# *Acheron*

RE: Response to Comments Final Major Subdivision Application Durant Homestead, Residential Subdivision.

Durant Homestead  
Whute Road, Windham, Maine  
Matt Hancock Properties  
PO Box 295  
Casco, Maine 04015

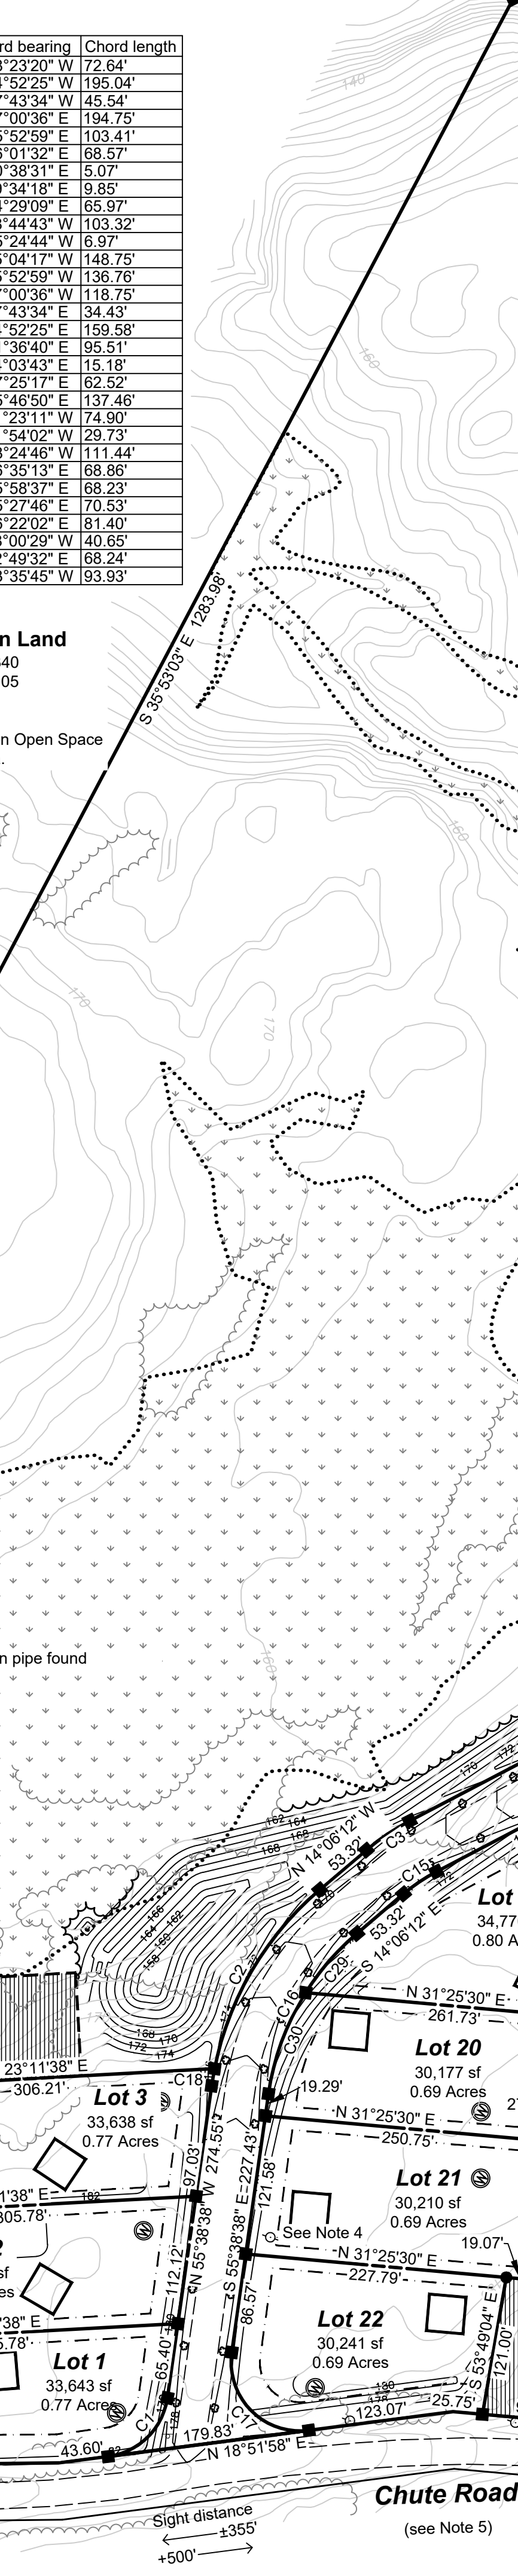
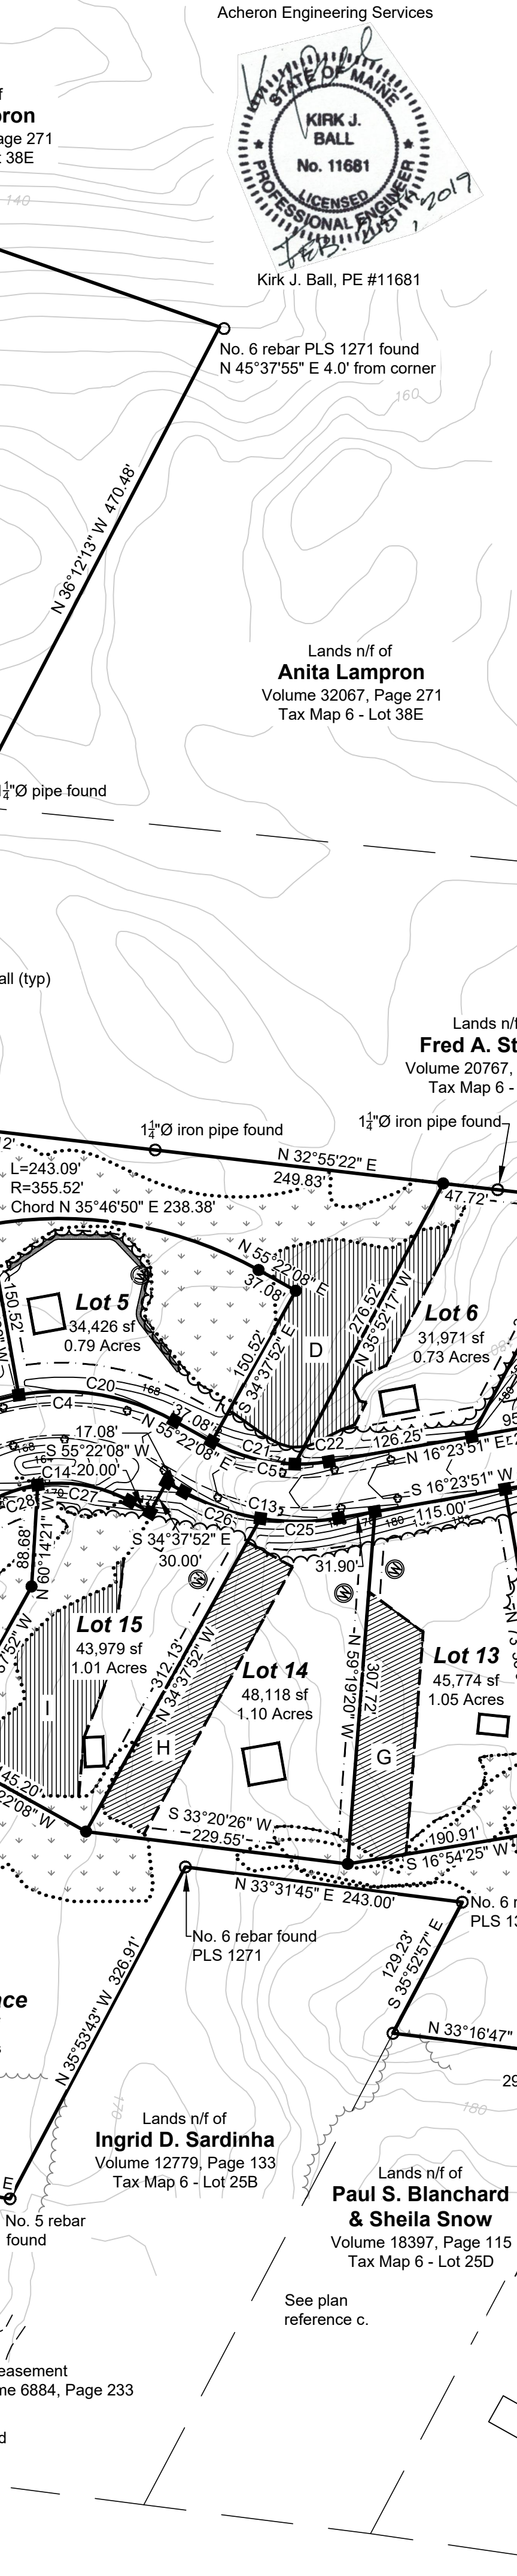
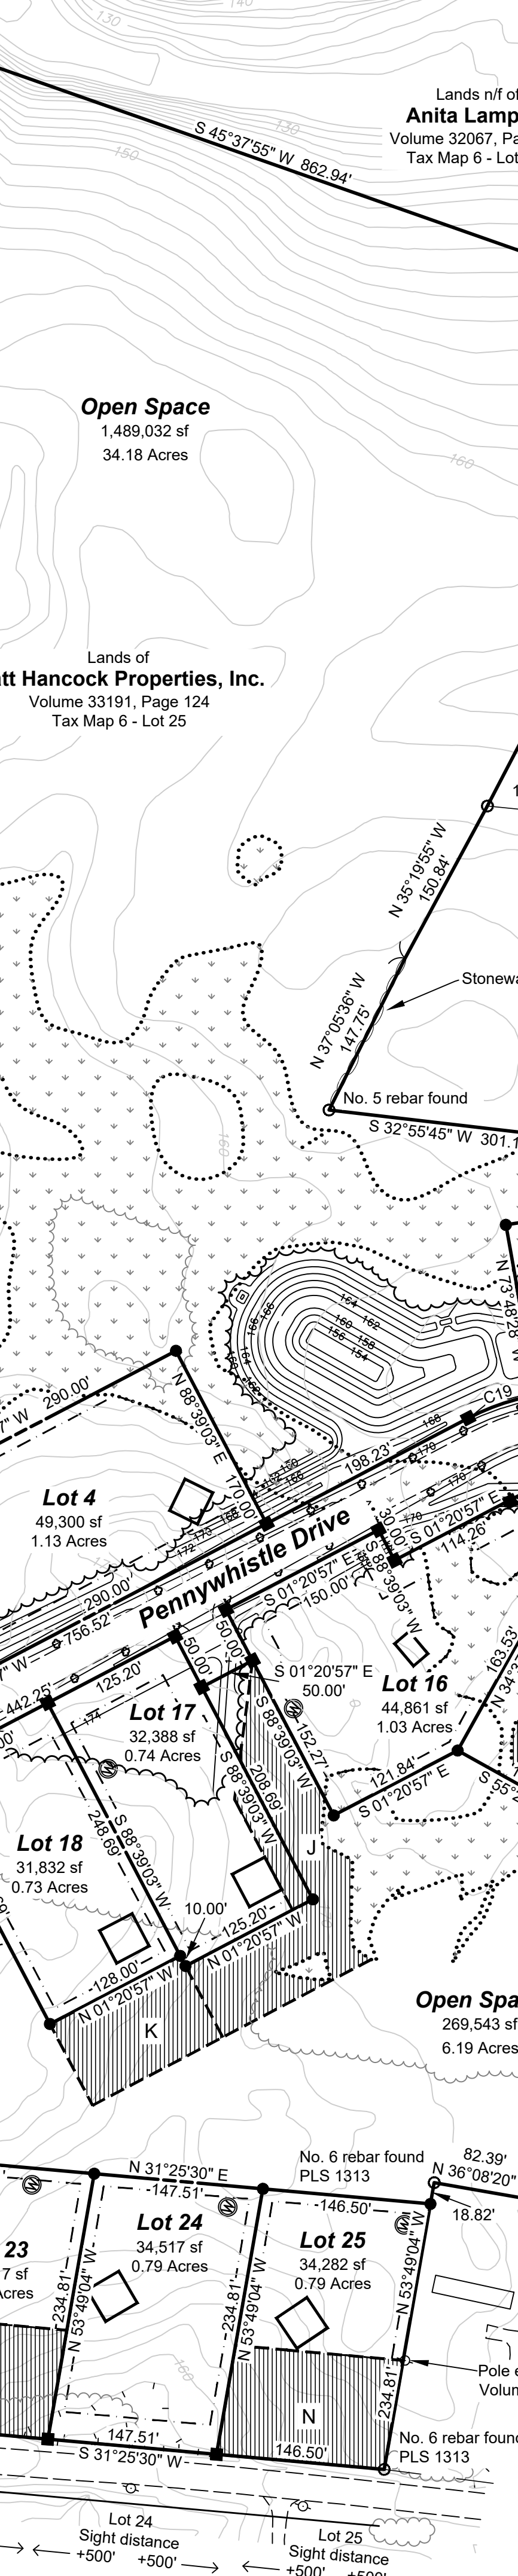
1. *Final Subdivision Plan (no sheet #) – Open space areas should be labeled similar to the lot areas.*

2. *Final Subdivision Plan (no sheet #) – As noted by Jon Earle in previous review, percentage of developable land in open space (Note 12) appears to be incorrect. The denominator does not match the total open space area provided in Note 11.*

3. *Final Subdivision Plan (no sheet #) – Plan shall be stamped by a Maine Licensed Professional Engineer and Professional Land Surveyor.*

4. *Final Subdivision Plan (no sheet #) – Granite Monuments shall be installed in accordance with Section 911.A.3(a).*

5. *Final Subdivision Plan (no sheet #) – Some proposed well locations are within 100’/50’ of the proposed travel way. As stated in Section 911.B.1(c)(1)(iii), wells shall not be constructed within 100’ downgradient of travelways or 50’ uphill from travelways*

6. *Final Subdivision Plan (no sheet #) – We recommend that the plan show all lot setbacks (front, side, rear).*

7. *Final Subdivision Plan (no sheet #) – We recommend that the plan include all space and bulk criteria for a cluster subdivision in a farm zone.*

8. *Final Subdivision Plan (no sheet #) – It should be noted that the proposed tree line does not appear to include the proposed lot development.*

9. *Final Subdivision Plan (no sheet #) - As the stormwater system has been designed to accommodate the proposed impervious and developed areas, as shown on this plan, any changes to the proposed lot development areas may require revisions to the proposed stormwater treatment systems.*

The Final Subdivision Plan, attached has been revised to include labels for the open space areas that are similar to the lot labels.

The area of land proposed in open space equals 40.37 acres as indicated in Note 11. This figure includes areas that are not developable (wetlands and slopes over 25%). The developable area designated as open space equals 27.20 acres. This figure is the area designated as open space minus wetlands and slopes over 25% (40.37 acres - 13.17 acres). Note 12, calculates the percentage of reserved open space within the full parcel. As mentioned above the developable area in open space is 27.20 and the developable area within the full parcel is 48.53 acres (same as net residential area),  $(27.20/48.53) = 56\%$ . Note 12 has been revised to clarify.

The attached Final Subdivision Plan include the design engineer's stamp and signature.

The Final Subdivision Plan has been revised per Section 911.A.3(a).

Water supply wells have been revised to meet the requirement of Section 911.B.1(c)(1)(iii). To meet the requirement on Lots 1, 2, 3 and 5, wells have been relocated and do not meet the standard 100 foot separation from a subsurface disposal system found in the Maine Subsurface Disposal Rules or the Well Drillers and Pump Installers Rules. However, Table 7A of the Maine Subsurface Disposal Rules and Table 400.1 of the Well Drillers and Pump Installers Rules allows for a reduction in the setback between a private potable water supply and a disposal field with design flows less than 1,000 gpd, based on the depth of well casing or liner seal below ground level, and LPI approval. With assistance from the Windham LPI, the State of Maine Site Evaluator was consulted and it has been determined that the LPI can approve the reduction in the setback in this case. Therefore, Matt Hancock Properties officially withdraws its waiver request from the requirements found in Section 911.B.1(c)(1)(iii).

The following note has been added to the Final Subdivision Plan to support this change:

“LOTS 1, 2, 3 AND 5: LPI APPROVAL REQUIRED FOR A REDUCTION IN SETBACK BETWEEN THE LEACHFIELD AND THE DRILLED WELL, TO INCLUDE GREATER DEPTH OF WELL CASING OR LINER SEAL BELOW GROUND LEVEL, AS PER TABLE 7A IN SECTION 7 OF THE SUBSURFACE WASTEWATER DISPOSAL RULES (AS AMENDED AUGUST 03, 2015).”

The Final Subdivision Plan has been revised to show structures setbacks.

The space and bulk criteria for a cluster subdivision is included on the attached version of the Final Subdivision Plan.

During the preliminary subdivision planning board review process, the Board approved a not showing the proposed tree line for the lots that are not regraded to meet stormwater standards. The basis for this approval is the Durant Homestead Stormwater Treatment Level Summary Table on Sheet C-5 which specifies the amount of impervious and developed area allowed on each lot. This table allows, the contractor, owner and inspectors to easily determine the limit of clearing and development for each lot in the field.

There are no changes to the lot development that will require revisions to the stormwater management plan.

Drawing No:  
C-6

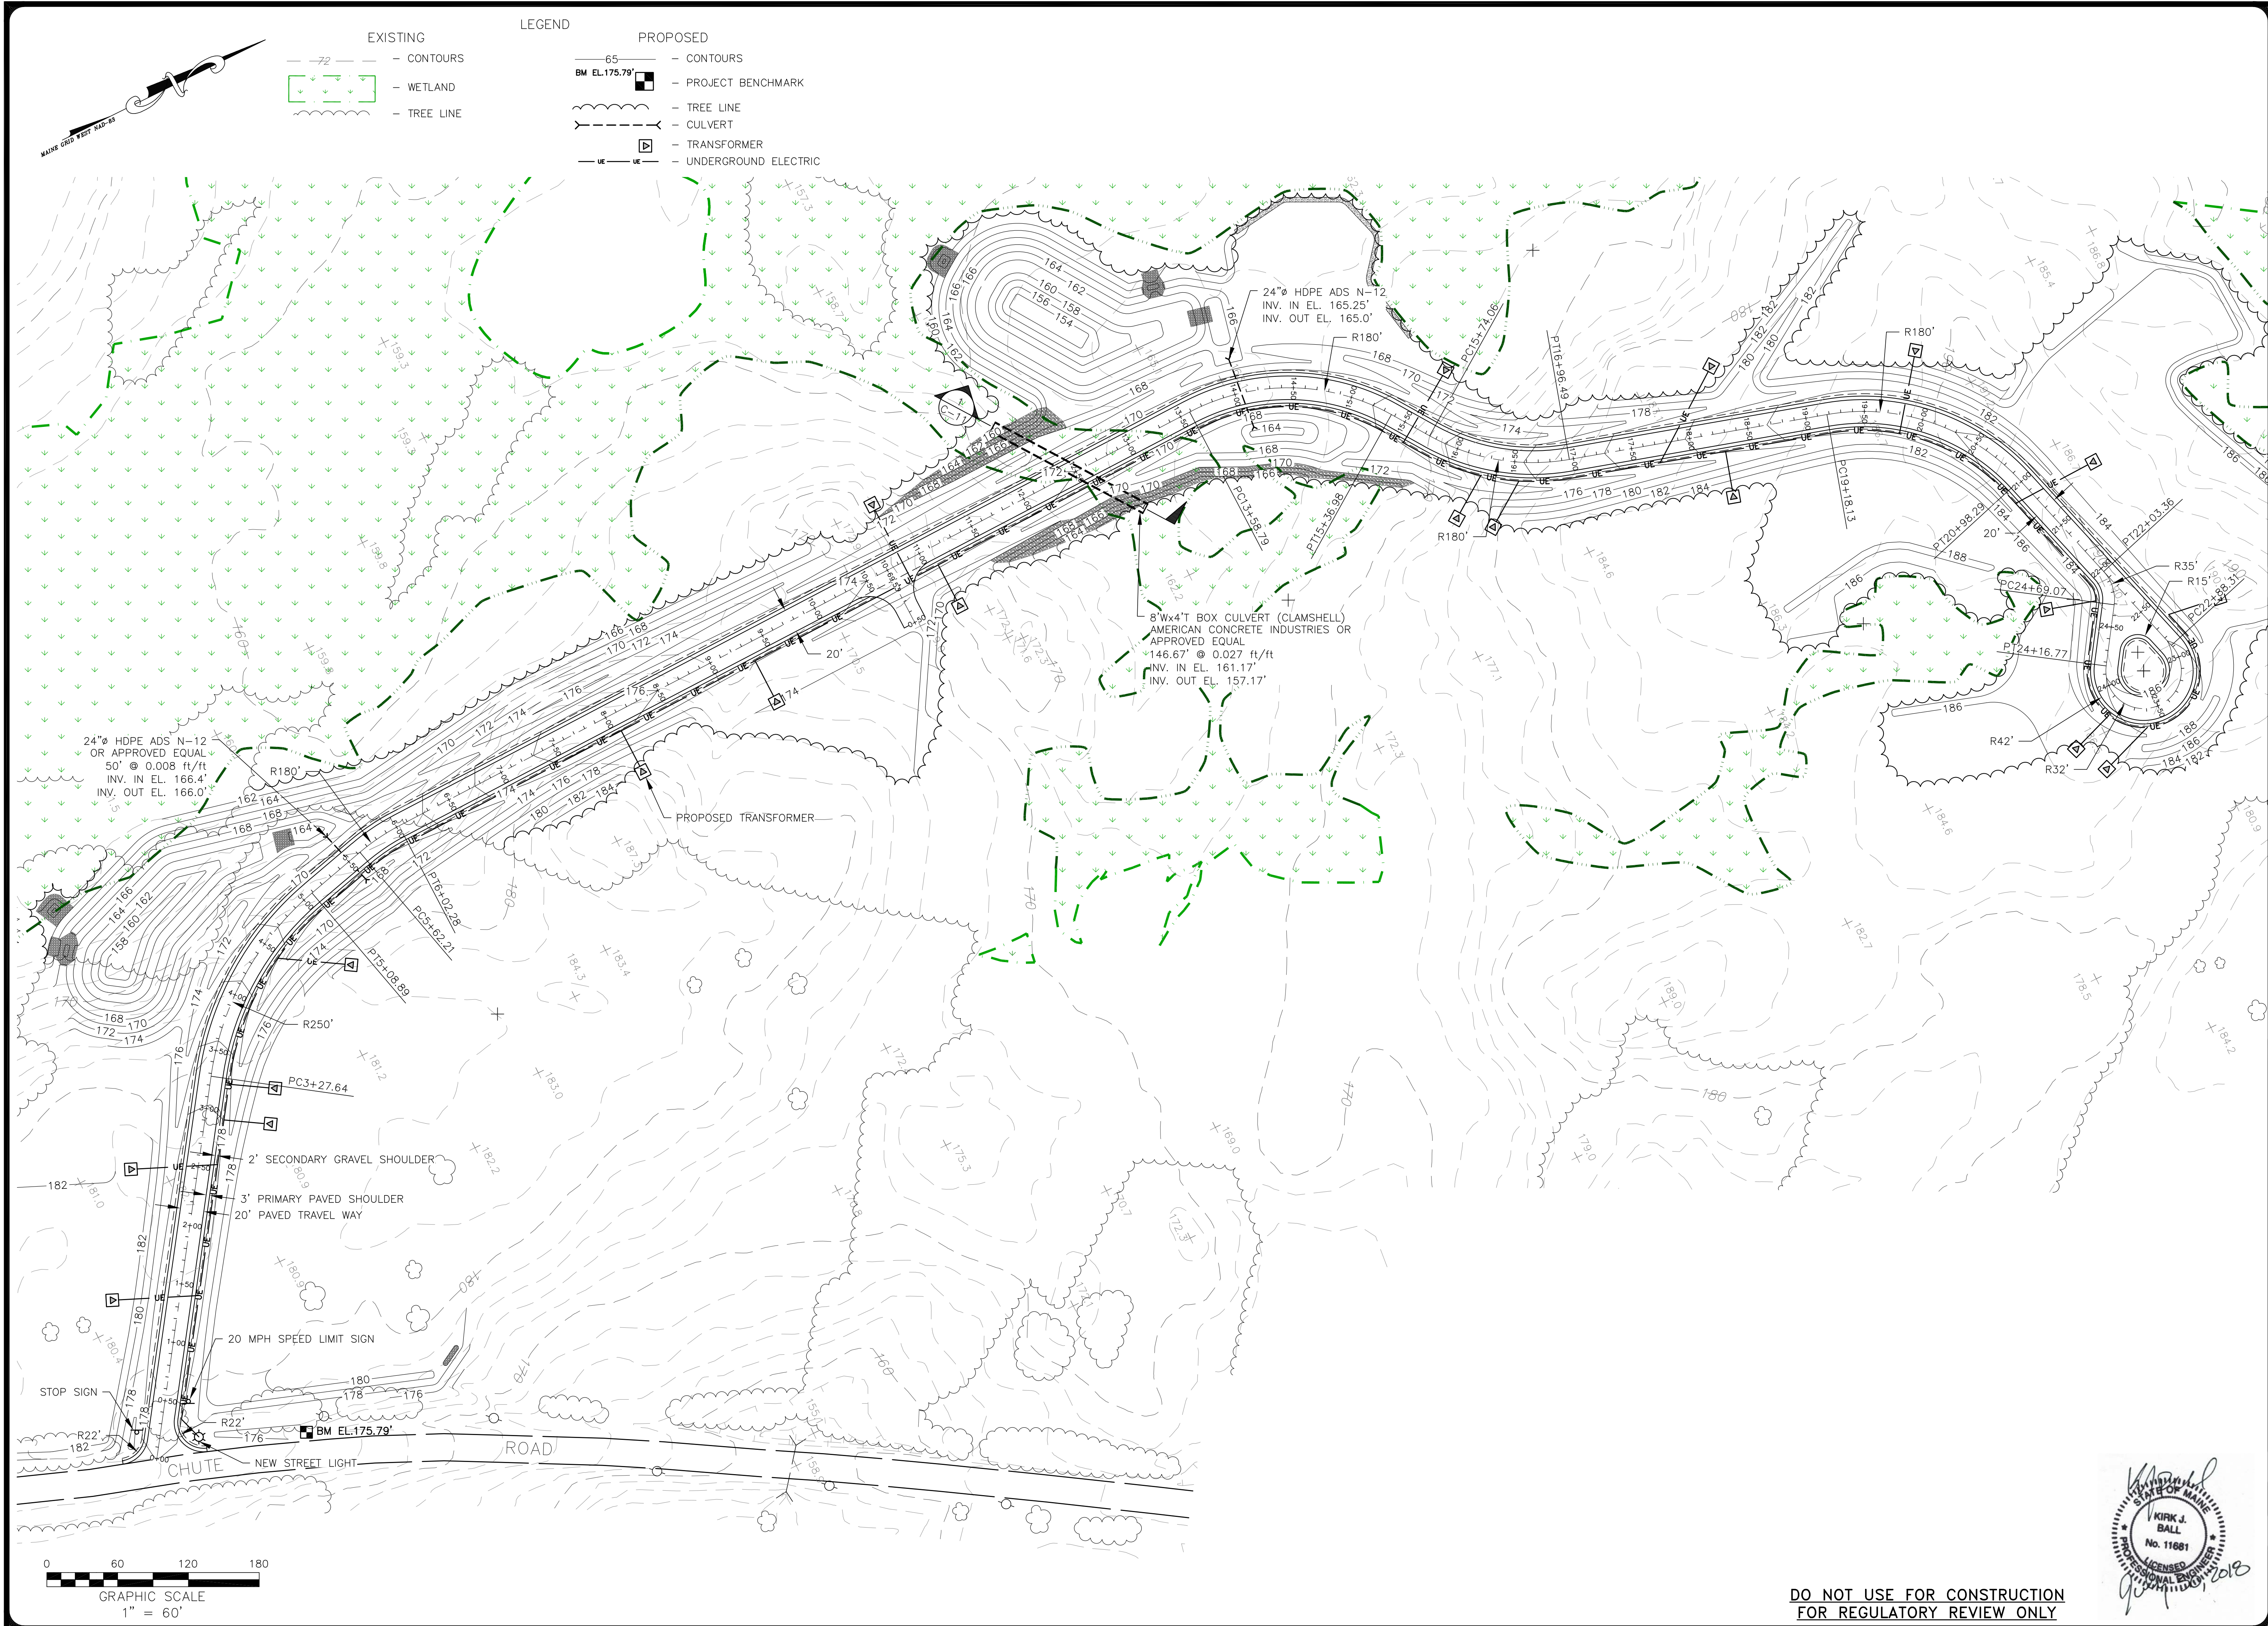
10. *Site Plan (C-6) – Construction entrance does not appear to be shown in the correct location.*

11. *Site Plan (C-6) – Building envelopes/setbacks should be revised to exclude any wetlands within the lots.*

The construction location has been relocated on sheet C-6 to the edge of pavement of Chute Road.

Site Plan C-6 and the Final Subdivision Plan have revised to include a setback line in the same location as the wetland boundaries within lots. In addition, a note has been added to plans that indicated wetlands are excluded from the building envelope.
